Automotive Silicon Errata and Data Sheet Clarifications

ATtiny202/204/402/404/406 Automotive

Figure 25-1. USART Block Diagram

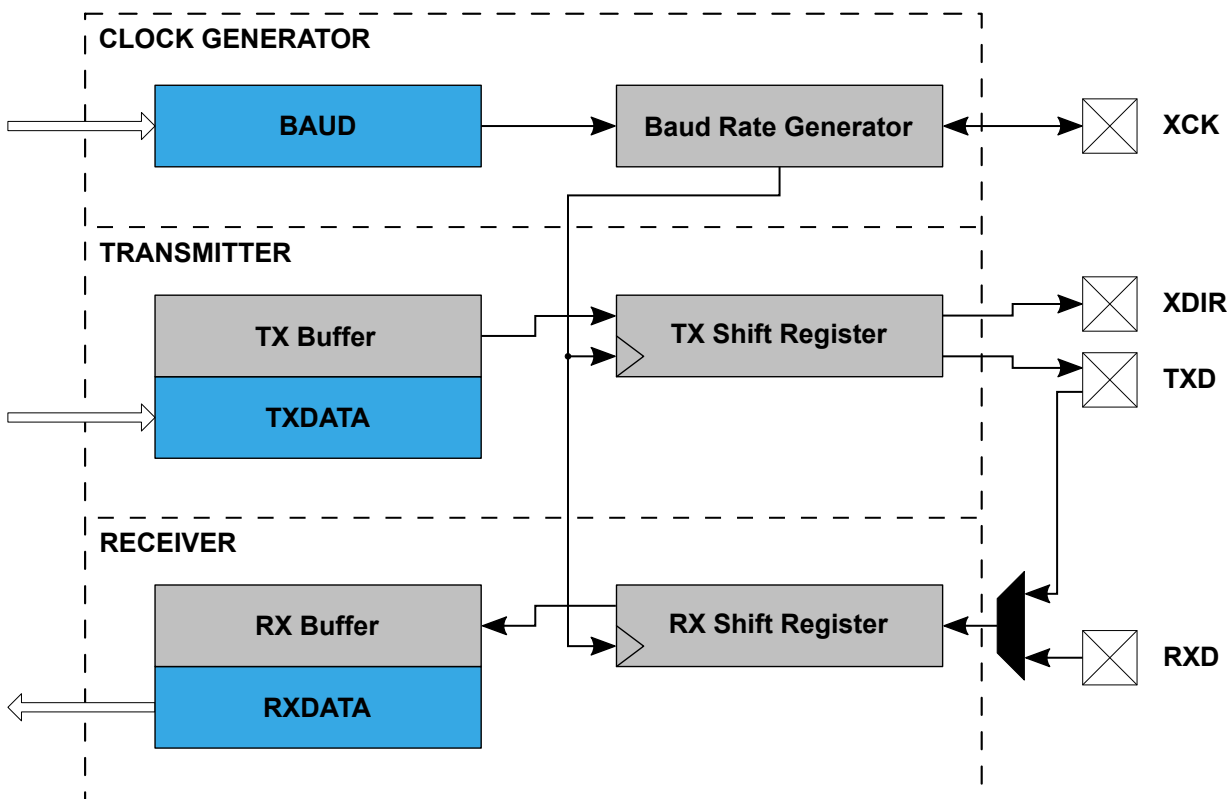
The block diagram is missing that USART TX is double-buffered from *Figure 25-1* in the data sheet. The figure below shows the added **TX Buffer**.

The transmitter consists of a **two-level** write buffer.

The data transmission is initiated by loading the **Transmit Data (USARTn.TXDATAL and USARTn.TXDATAH)** registers with the data to be sent. The data in the **Transmit Data registers are moved to the TX Buffer** once emptied and then to the Shift register once it is empty and ready to send a new frame.

Figure 3-1. Package Marking Information

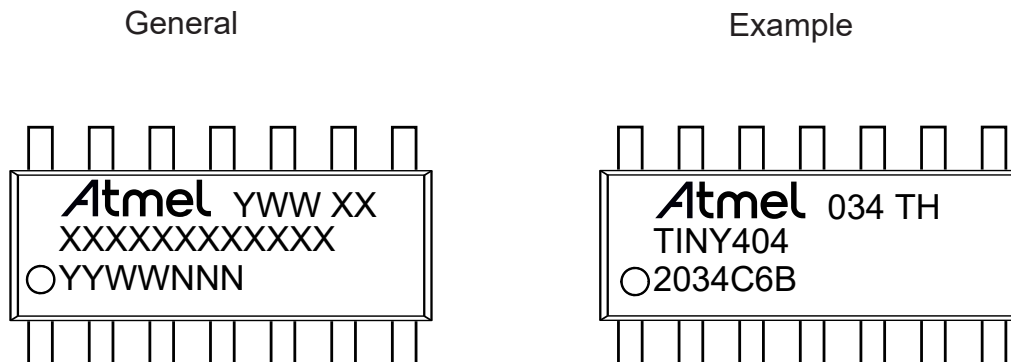
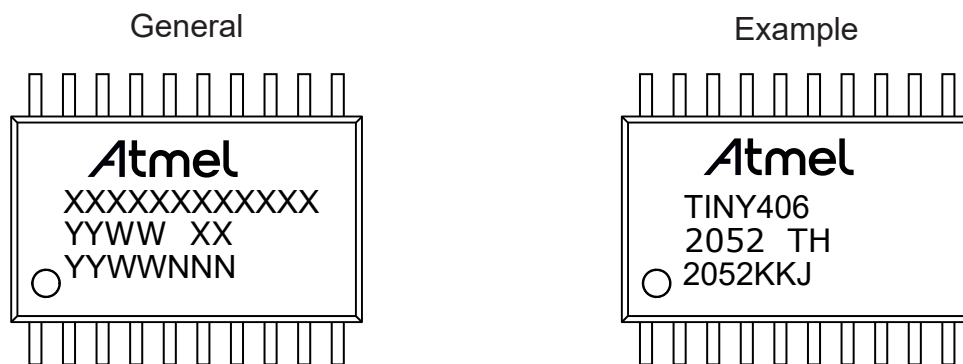
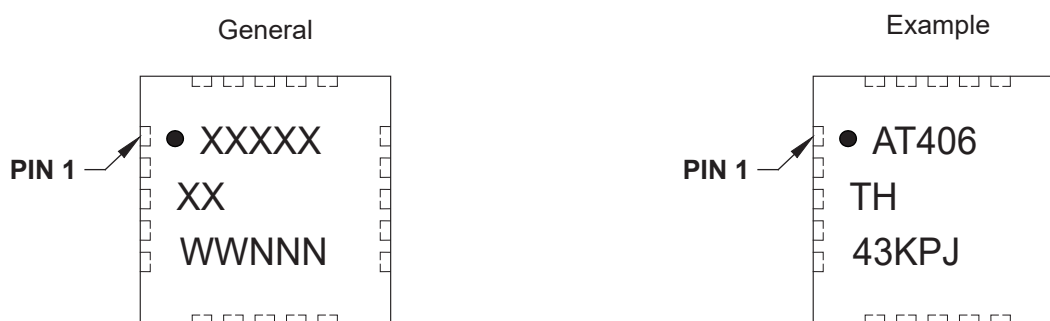
Package marking information is missing in the data sheet. This section contains all package marking information for:
